MIL-PRF-19500/741B
w/AMENDMENT 3
13 November 2025
SUPERSEDING
MIL-PRF-19500/741B
w/AMENDMENT 2
24 March 2025

PERFORMANCE SPECIFICATION SHEET

TRANSISTOR, DIE, FIELD EFFECT, RADIATION HARDENED (TOTAL DOSE AND SINGLE EVENT EFFECTS) N-CHANNEL AND P-CHANNEL, SILICON, VARIOUS TYPES, JANHC AND JANKC

FIGURE 13. JANHC and JANKC A-version die dimensions, 2N7616.

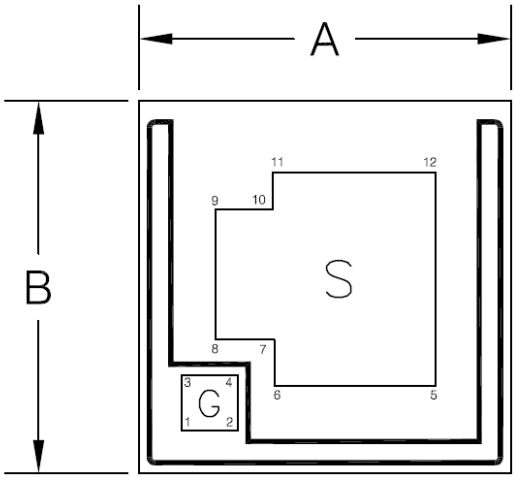
NOTES:
1. Dimensions are in micrometers. Mils are given for general information only.
* 2. Top metal: Al-1%Si-0.5%Cu; 5.7 µm thick respectively.
* 3. Back metal: Ti/NiV/Ag; 0.1 µm / 0.45 µm / 0.6 µm thick, respectively.
4. All dimensions are valid for all radiation hardness levels specified.
5. Backside metal is the drain connection.
* 6. Die thickness: 240 µm (9.4 mils).
7. For sawn die, outline dimensions (A and B) will be reduced by 25 µm (0.98 mils), due to saw kerf.
8. Die bond pad coordinates are provided for use in automated bonding equipment. Key locations 1 through 12 refer to adjacent gate/source pad corners. Key 2 through 12 are relative to Key 1.
9. See 6.2 and 6.5 for ordering information.

FIGURE 14. JANHC and JANKC A-version die dimensions, 2N7626.

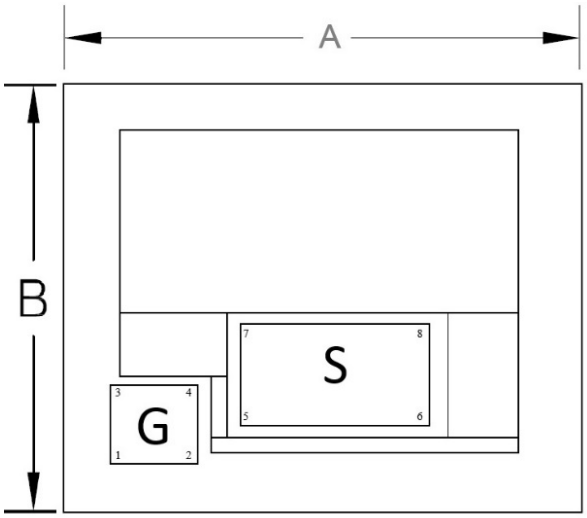
NOTES:
1. Dimensions are in micrometers. Mils are given for general information only.
* 2. Top metal: Al-1%Si-0.5%Cu; 5.7 µm thick.
* 3. Back metal: Al/Ti/NiV/Ag; 0.1 µm/0.1 µm/0.45 µm/0.6 µm thick, respectively.
4. All dimensions are valid for all radiation hardness levels specified.
5. Backside metal is the drain connection.
* 6. Die thickness: 240 µm (9.4 mils).
7. For sawn die, outline dimensions (A and B) will be reduced by 25 µm (0.98 mils), due to saw kerf.
8. Die bond pad coordinates are provided for use in automated bonding equipment. Key locations 1 through 8 refer to adjacent gate/source pad corners. Key 2 through 8 are relative to Key 1.
9. See 6.2 and 6.5 for ordering information.
